**Independent Committee for Extraordinary Advisory on  
Dam Safety  
Final Report  
April 30, 2021**

## **Introduction**

The fundamental purpose of the Committee was to advise the Board of Directors on issues related to the diagnosis of safety conditions, management and mitigation of risks related to Vale's dams, as well as to recommend measures to be taken to strengthen their safety conditions.

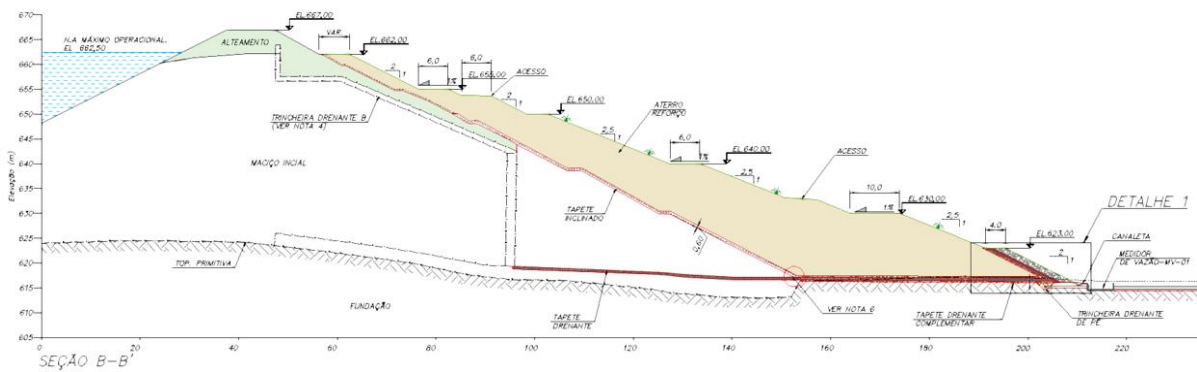
A typical cross-section shows that the water levels inside the compacted earth embankment are high and indicate poor performance of the first stage chimney filter.

The dam will be reinforced with a berm on the downstream slope as shown in the figure below, with a sand filter in the interface with the existing earthfill. This reinforcement berm will bring the factor of safety to levels higher than 2.

#### B-7 Dam

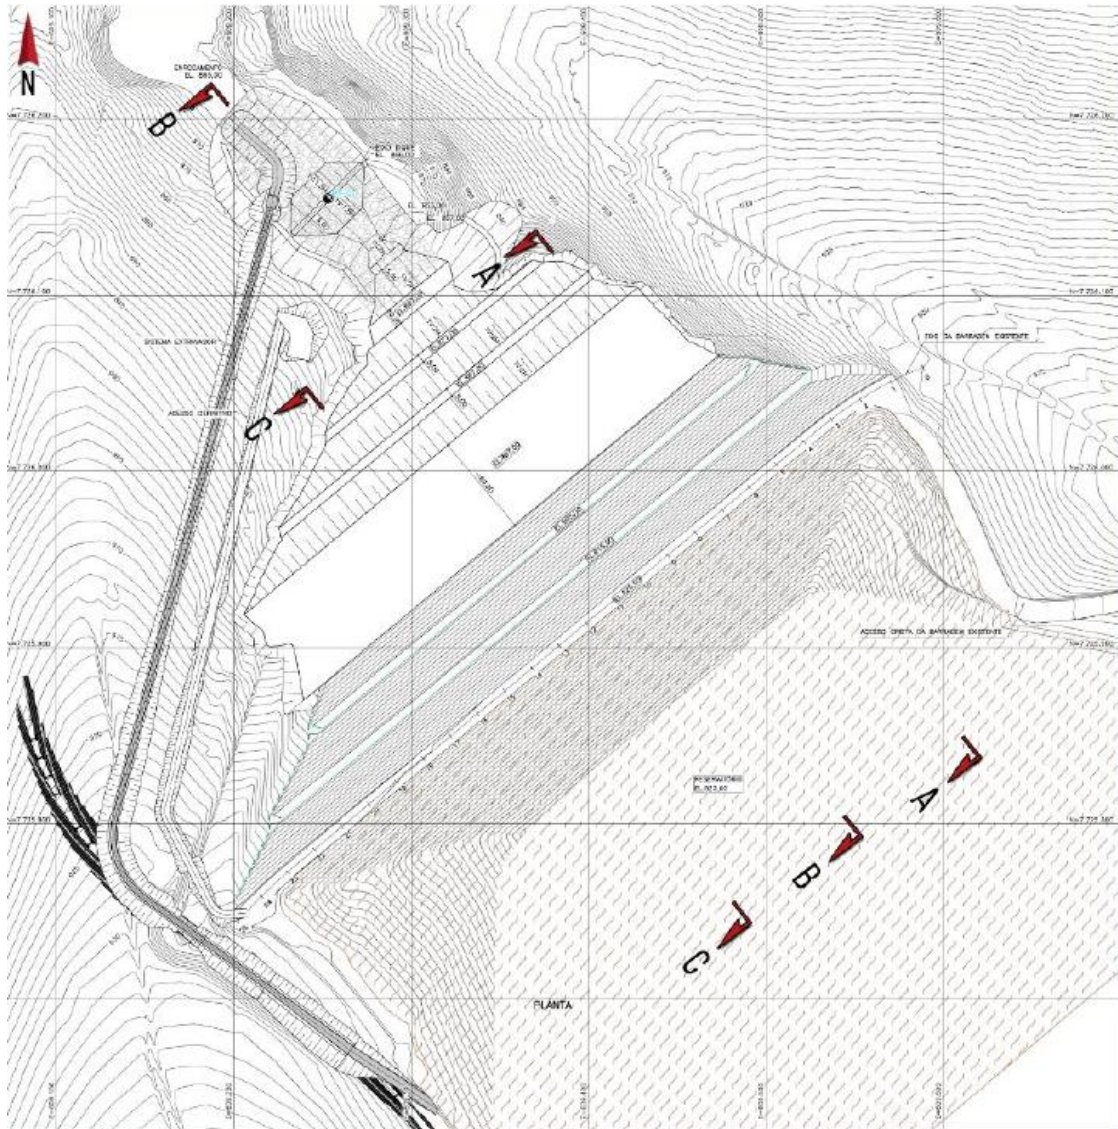
- It is necessary to evaluate in detail the influence of the excavation proposed in conceptual design – up to 12 m deep in the region just downstream of the dam toe - on the stability of the downstream slope of the existing dam during the first phase of construction of the proposed earth buttress. Stability analyses of the current embankment considering this excavation of the alluvium may certainly require even lower water levels in the reservoir than is currently maintained.

- The need for the large extent of the removal (about 100 m) proposed in the conceptual project was questioned – excavation that would later be filled by rockfill - because the new berm will be supported practically outside of this large excavation.
